Supplement C
Changes as of Model Year 1987

Model 107

2-Function refrigerant pressure switch

Fig. 83/3

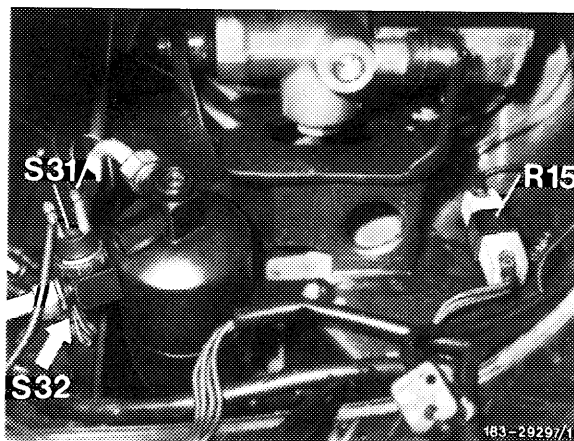
To prevent damage to the A/C compressor, a 2-function refrigerant pressure switch (S 31/1) is installed in the receiver/dryer replacing the previous switch.

1. Function 1 (low pressure) activates if the refrigerant level is too low or with no refrigerant in system.

Cut-out pressure is approx. 2.0 bar.

Cut-in pressure is approx. 2.6 bar.

2. Function 2 (high pressure) activates if the expansion valve becomes clogged or if the auxiliary fan fails to operate.

Cut-out pressure is approx. 30.0 bar.

Cut-in pressure is approx. 22.0 bar.
